Proposed Temporary Logistics Centre for a Period of 3 Years

Annex 1 Drainage Assessment

TPB Ref.: A/YL-PH/944

Proposed Temporary Logistics Centre for a Period of 3 Years at Lots 170 S.A, 170 B & E ss.3 (Part), 175 A.B.C.D.E.G S.A, 815 & 816 A.B. (Part) in D.D.111, Pat Heung, Yuen Long, N.T.

Photo 1 Photo showing the existing condition of drainage facilities

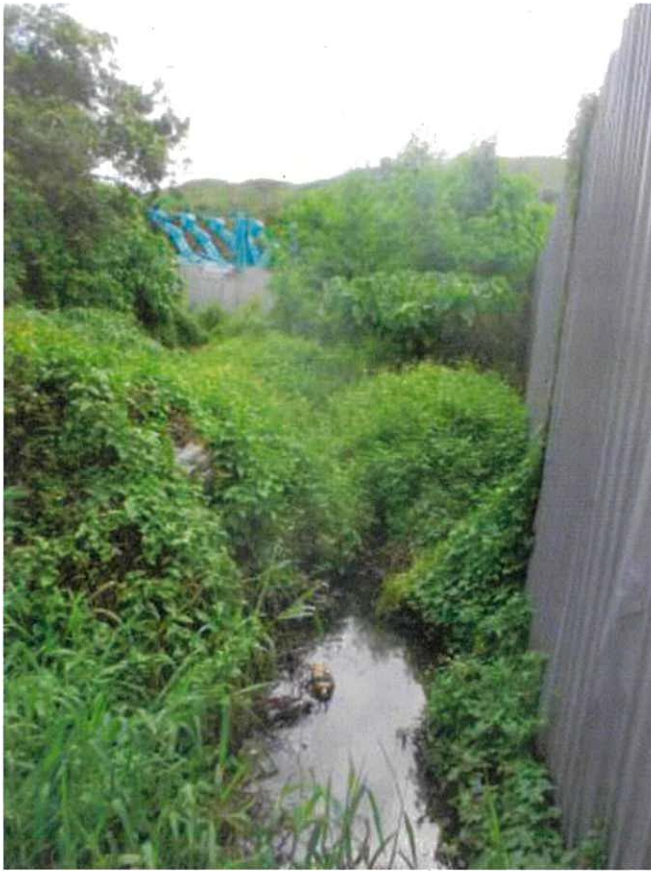
(e) Please provide the connection details of the discharge point as well as photo record showing the existing drainage facilities' condition as mentioned in (d).	Noted. Please see Figure 5 and photo below.

Figure 4

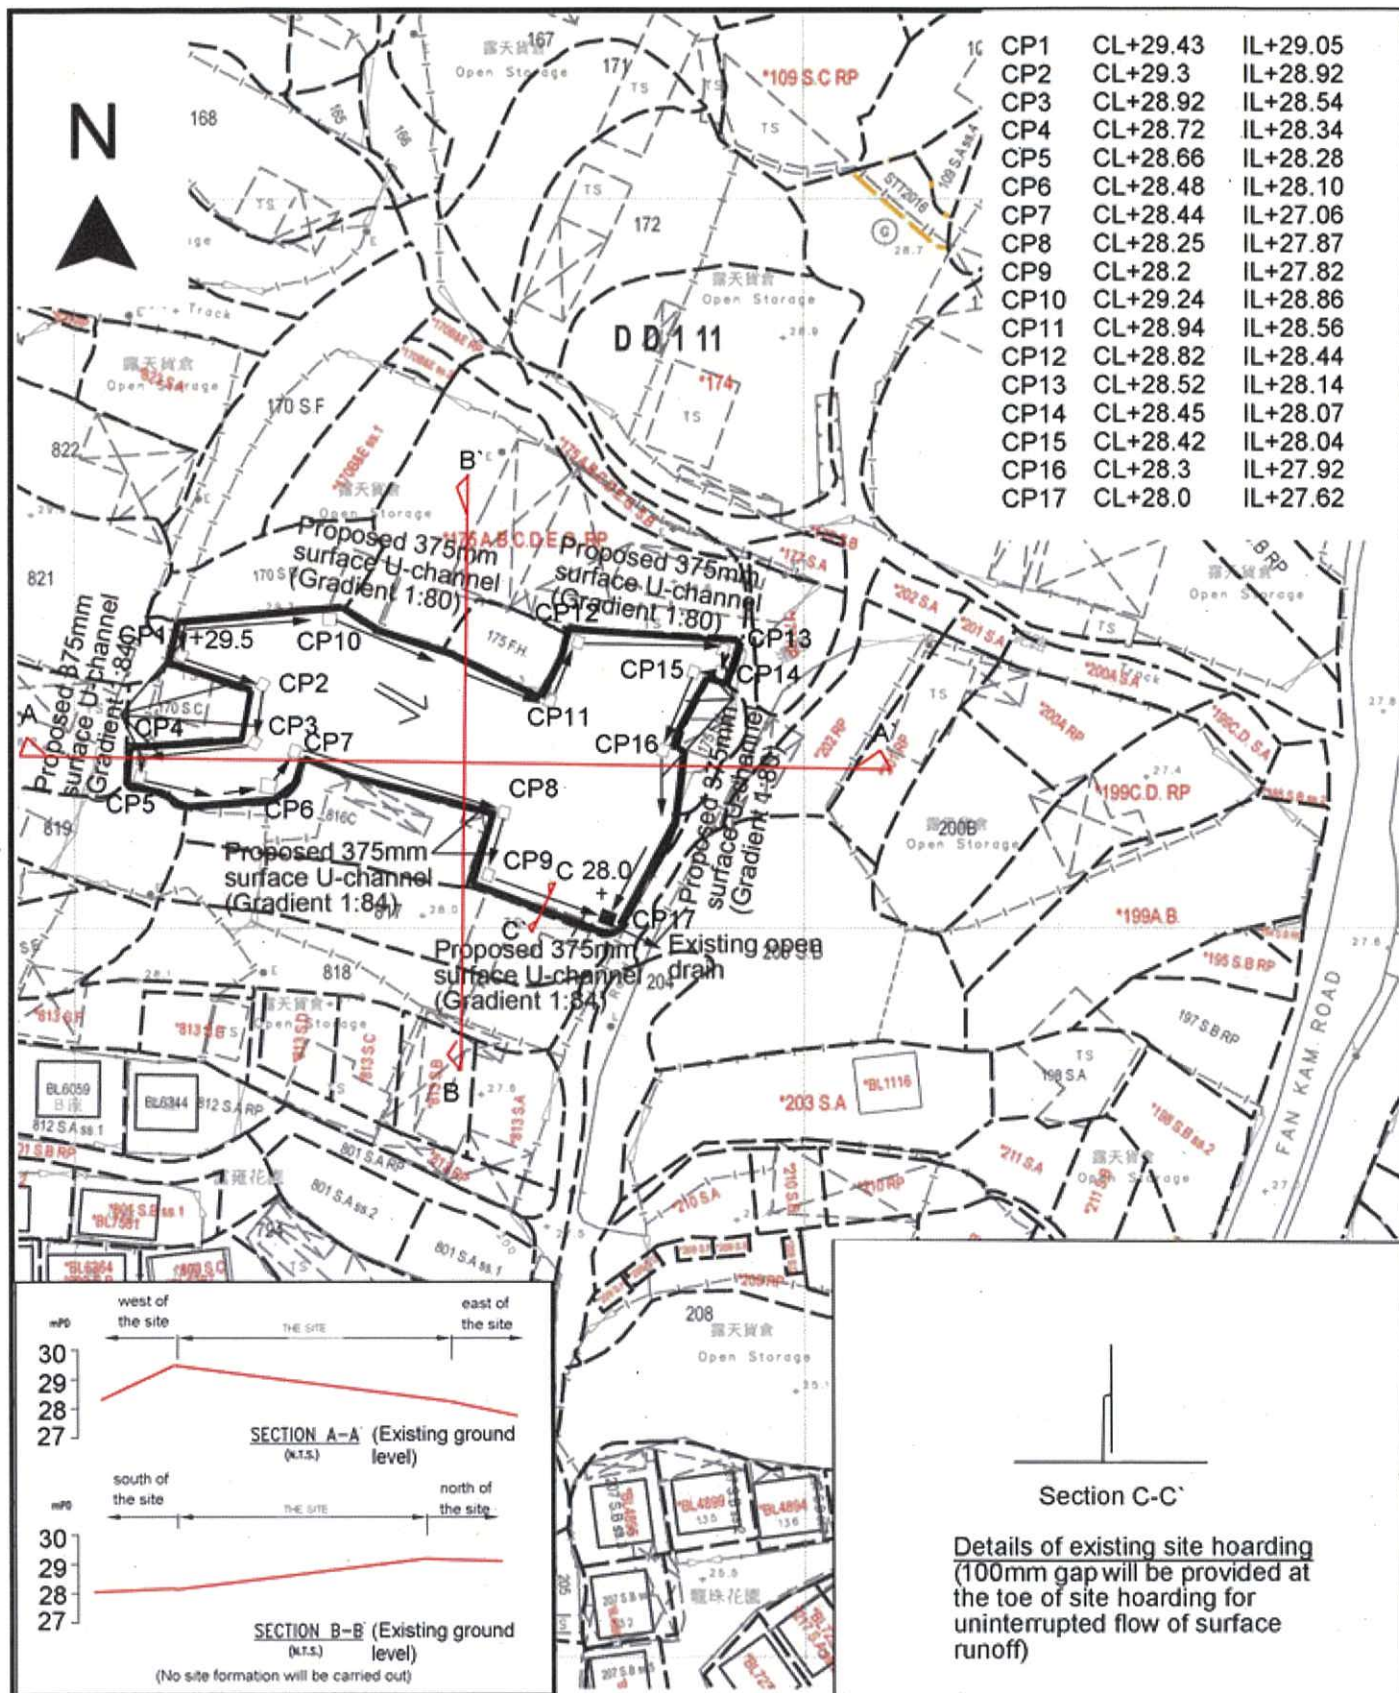
(b) Consideration should be given to provide catchpit at the turning points of the u-channel.	Noted.
(c) The cover levels and invert levels of the proposed u-channels, catchpits /sand traps should be shown on the drainage plan. All proposed catchpits should also be numbered such as CP1, CP2 for easy reference.	Noted. Please see Figure 4.

(g) The location and details of the proposed hoarding/peripheral wall should be shown on the proposed drainage plan.	Noted. Please see Figure 4. 100mm opening will be provided at the toe of the site hoarding. No peripheral wall is proposed.

(h) Cross sections showing the existing and proposed ground levels of the captioned site with respect to the adjacent areas should be given.	Noted. Please see Figure 4.

Details of Proposed
Surface U-channel

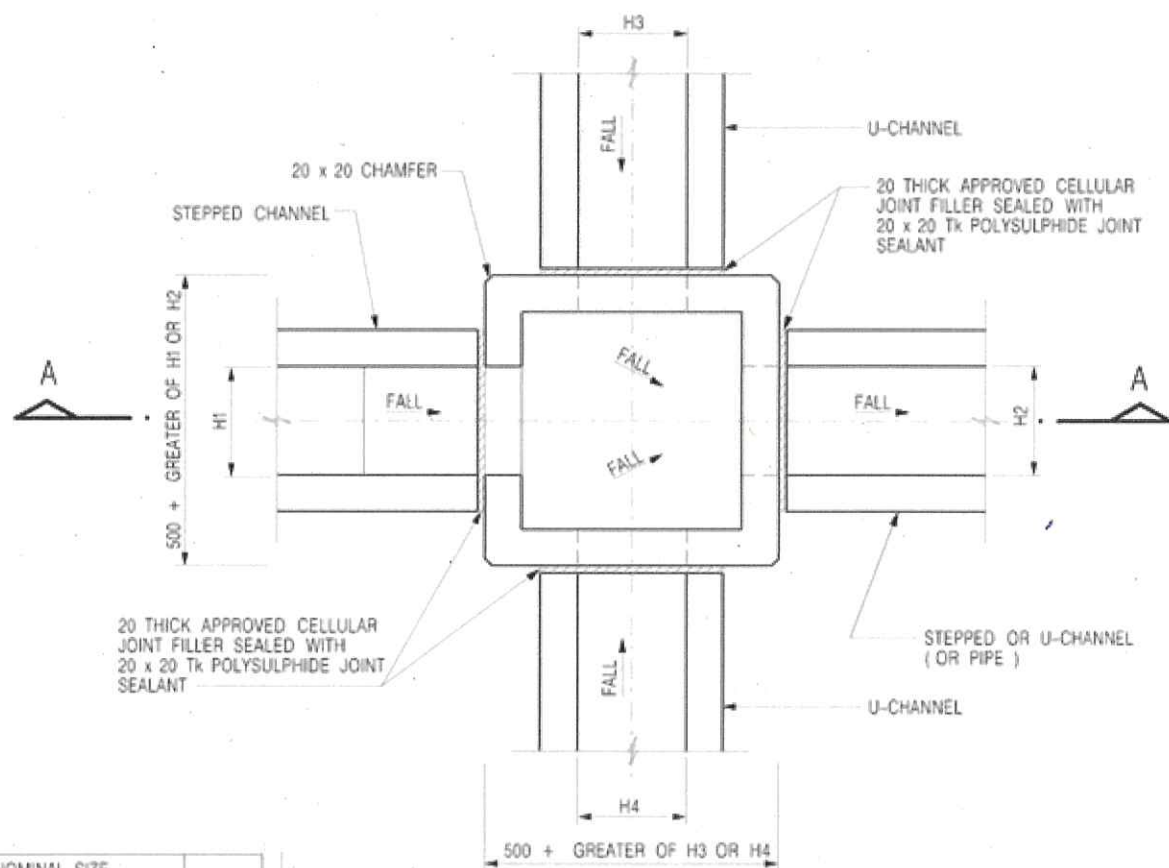
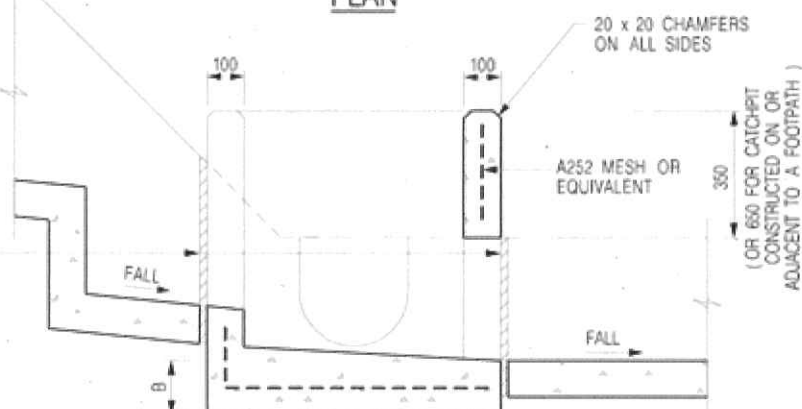
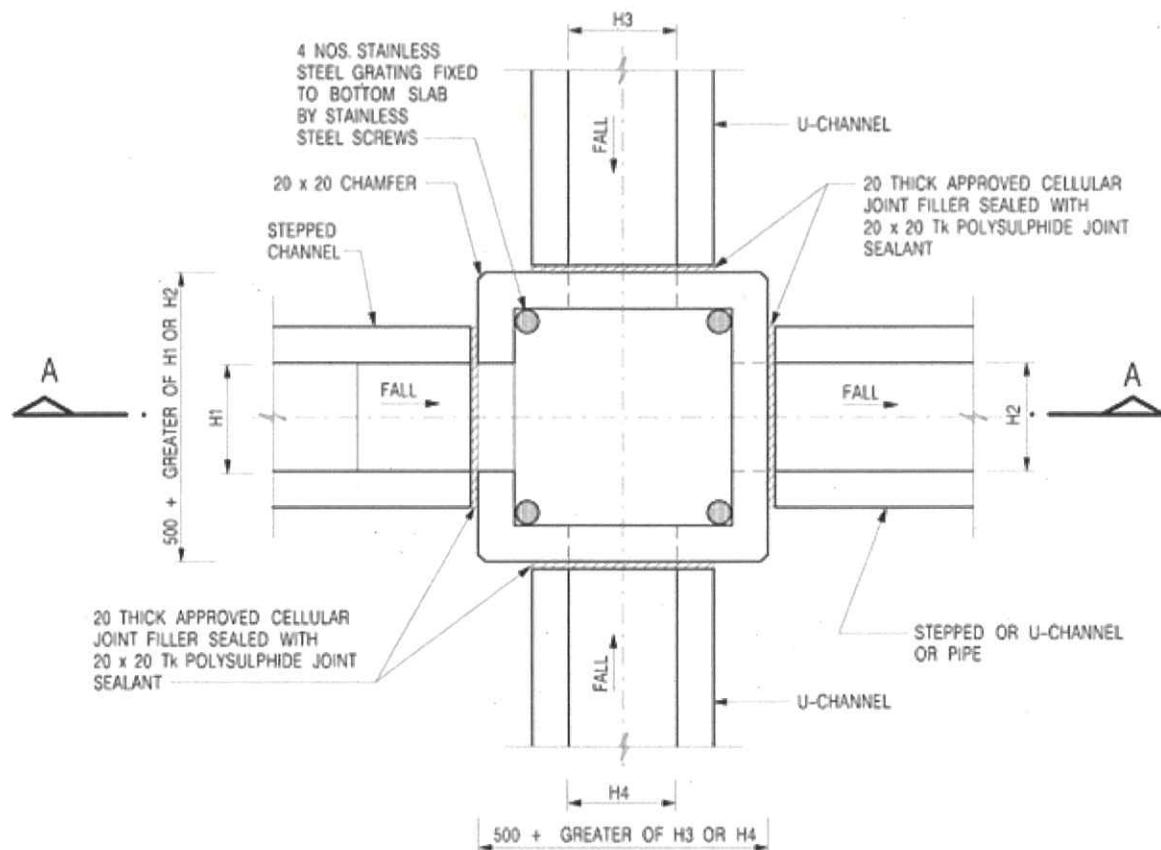
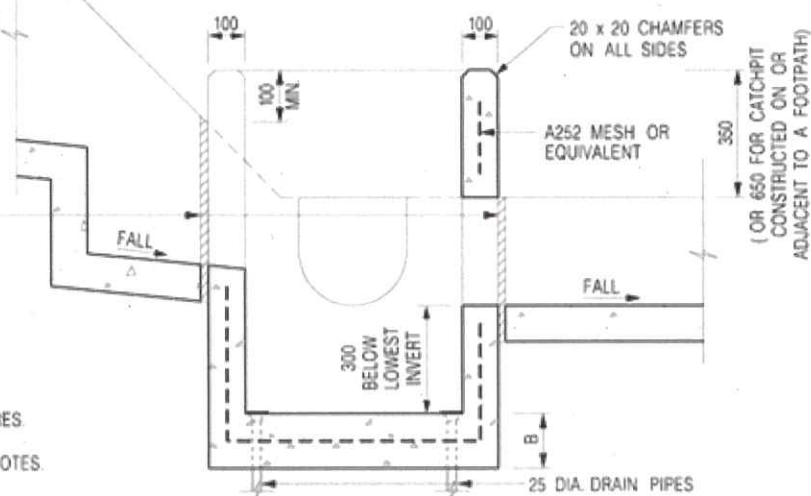
(i) Standard details should be provided to indicate the sectional details of the proposed u-channel and the catchpit/sand trap.	Noted. Please see Figure 6 to 8.

Figure 9

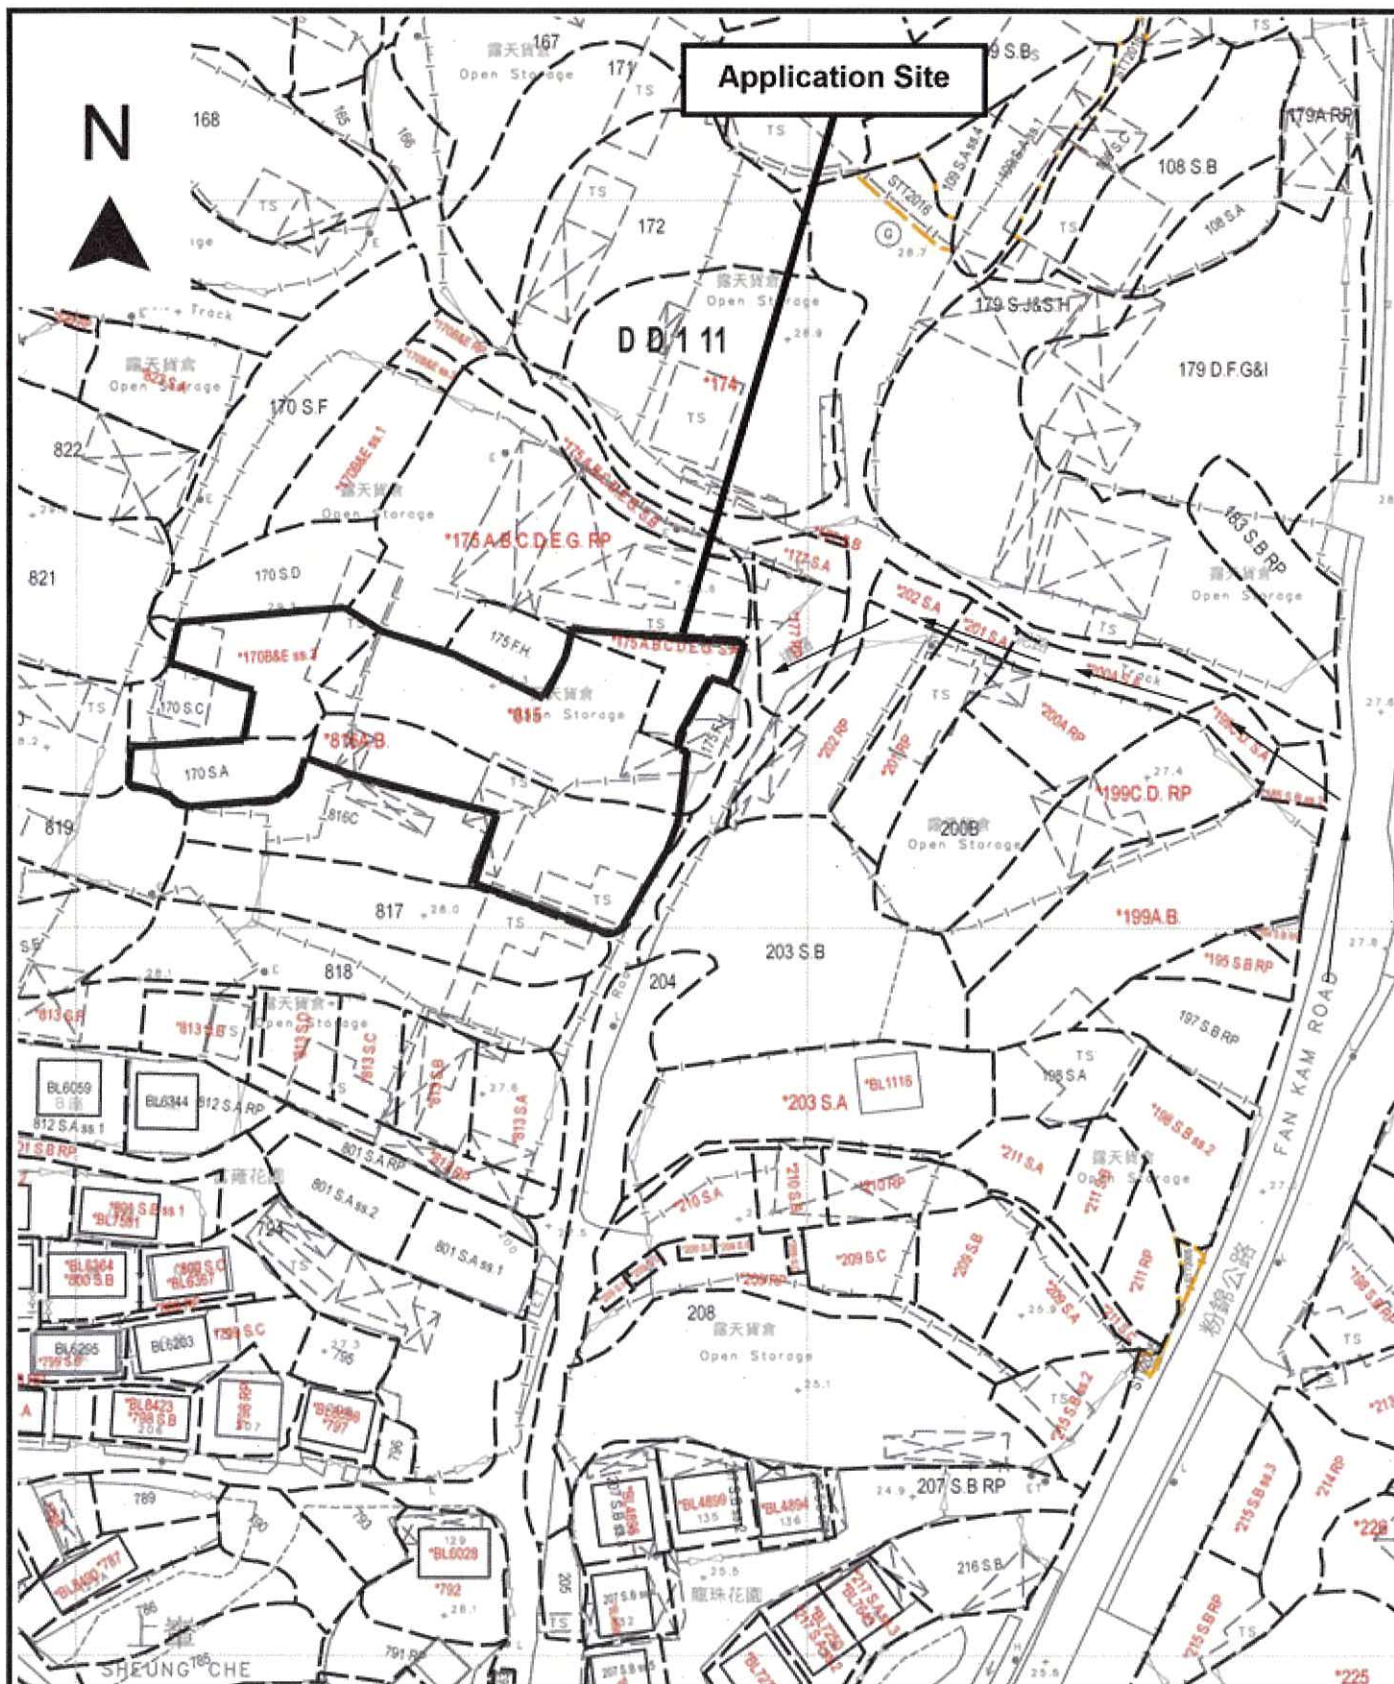
Transport Department's comments	Applicant's response
The applicant should provide the routing between Fan Kam Road and the application site.	Noted. Please refer to Figure 9.
